P.O.A.D.P. # 538B

ROGERS RANCH
San Antonio, Texas
PRELIMINARY OVERALL AREA DEVELOPMENT PLAN

Re: Rogers Ranch (Amendment) MDP # 538 B

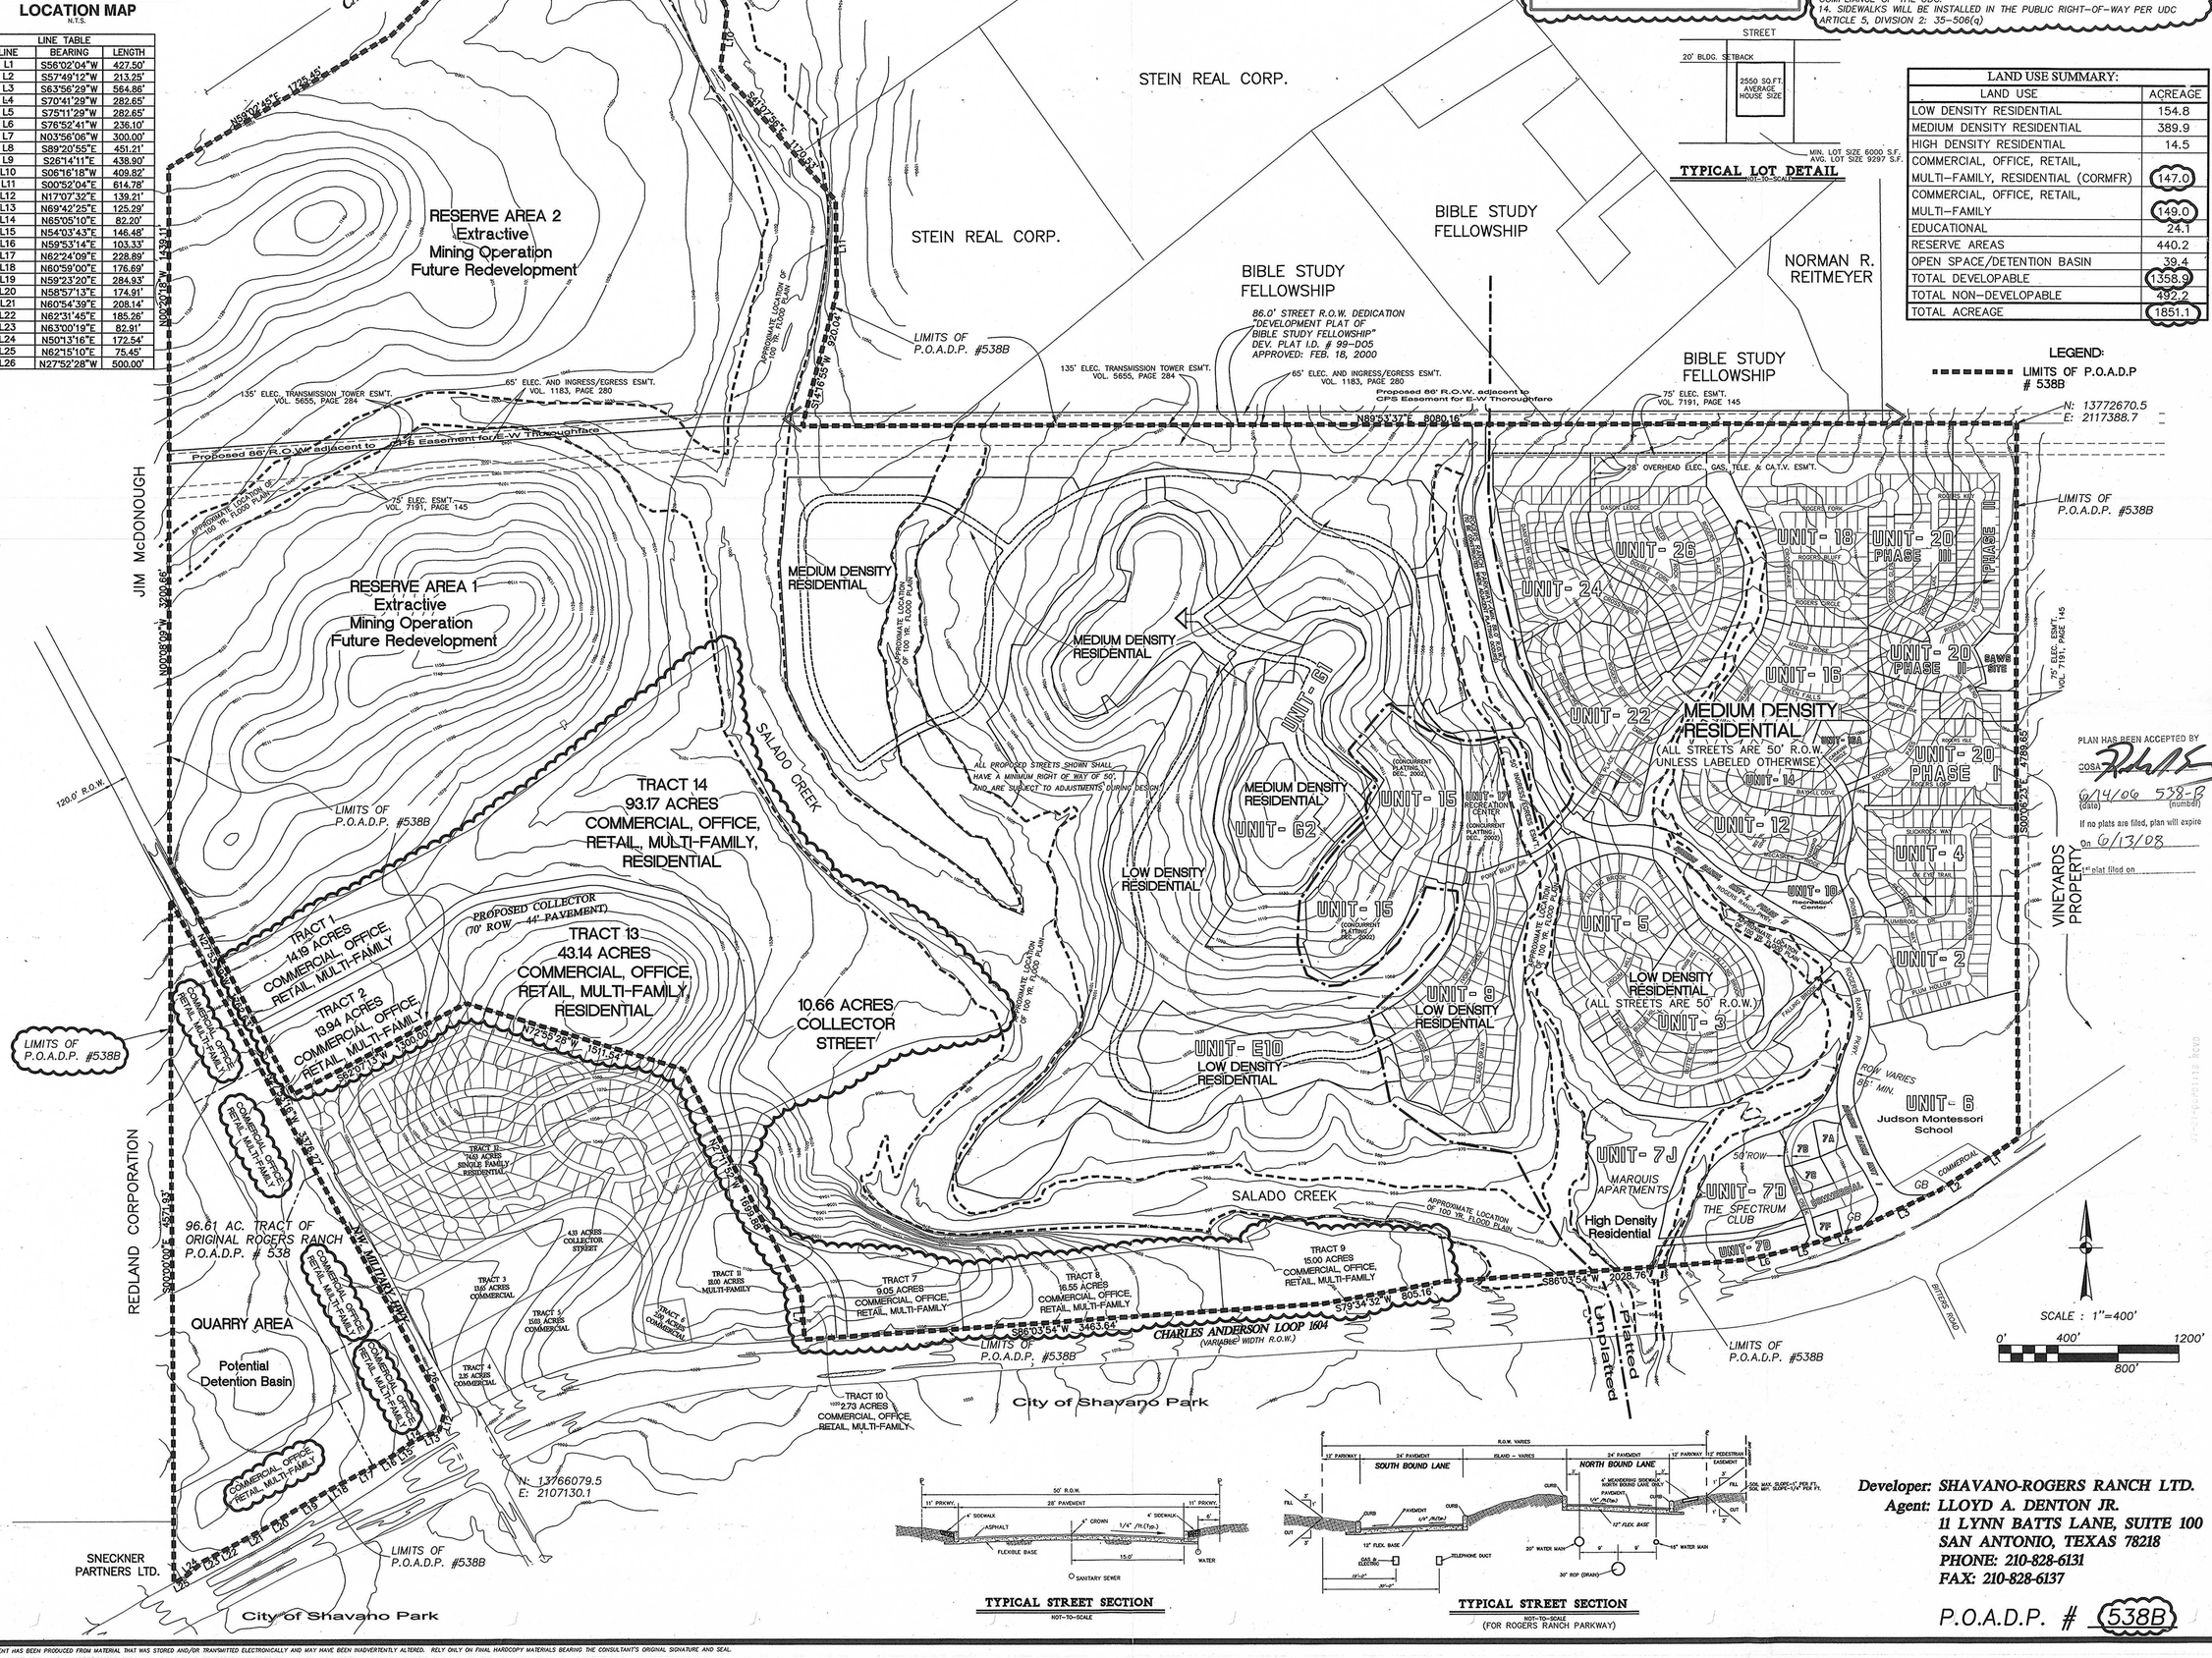
- In consideration of public safety and convenience, excessive grades by reason of topography should be avoided in street layouts and arrangements.

- Any access and R.O.W. issues along state facilities will need to be resolved with the **Texas Department of Transportation (TXDOT)**. For information about these requirements you can contact TXDOT at 615-5814.

The Development Services **TIA & Streets Division** has reviewed the Level-3 Traffic Impact Analysis (Parsons TIA dated October 2000 and the revised POADP Memo dated August 10, 2005) for the Rogers Ranch (Amendment 538 B) (MDP). The analysis is in compliance with TIA Ordinance 91700.

This proposed development is located on the north side of 1604, and on the east side of North West Military within the city limits. Current proposal consists of 181 single-family residential, 1,596 multi-family residential, 593,000 sq. ft. office and 1,434,000 sq. ft.

shopping center. This development is estimated to generate 80,393 average daily trips, and 7,373 weekday PM peak-hour trips. The approval of Rogers Ranch (Amendment 538 B) MDP, represents only the approval of the collector street shown from 1604 north, turning west and connecting to NW Military Hwy. The original Parsons TIA dated October 2000 no longer is valid due to the abandonment of the development plan, and it's location of major streets. The TIA division understands (as stated in the Memo) that the revised POADP TIA Memo dated August 10, 2005 is only to highlight the differences in proposed development between the Parson's TIA and current plans. No site layouts, specific development plan or locations has been provided for the single-family, multi-family, office building, or shopping center areas in the 1604/NW Military area. It is understood that development plans may change. The TIA division shall require an appropriate TIA submitted for each development as they are proposed and come in for re-zoning, platting, and/or building permits. No specific development layout has been provided for the site including turning movements, internal private or public streets, or driveway locations onto 1604, NW Military or the proposed collector. The developer shall be responsible for providing right-turn deceleration lanes as well as left turn lanes, with storage lengths and bay taper as it relates to future development's TIA traffic counts, (Uniform Development Code (UDC) - 35-502 (a)(7), subsection C.

Regarding the approval of the collector street, the following requirements and on-site improvements are necessary and shall be provided by the developer, on and before the completion of the Rogers Ranch (Amendment 538 B), at no cost to the City of San Antonio: All access roadways shall provide clear sight distance on all existing and proposed roadways in order to provide adequate obstruction free viewing distances for approaching traffic. All signage, landscaping, and improvements shall be selected and located so as to not block these clear sight distance areas. All commercial driveways for this project shall comply with UDC 35-506, (r) Access and Driveways.
It should be understood that the submitted TIA concurrent with the proposed Rogers Ranch (Amendment 538 B) is a conceptual plan and therefore this document does not represent an approval for the internal street plan. All streets and driveways shall follow UDC 35-506 and the street network shall be planned in order to provide safe and efficient movement of traffic to and from, within and past, the proposed development, while minimizing the impact to non-site trips. UDC 35-506 will be implemented at the time of platting.
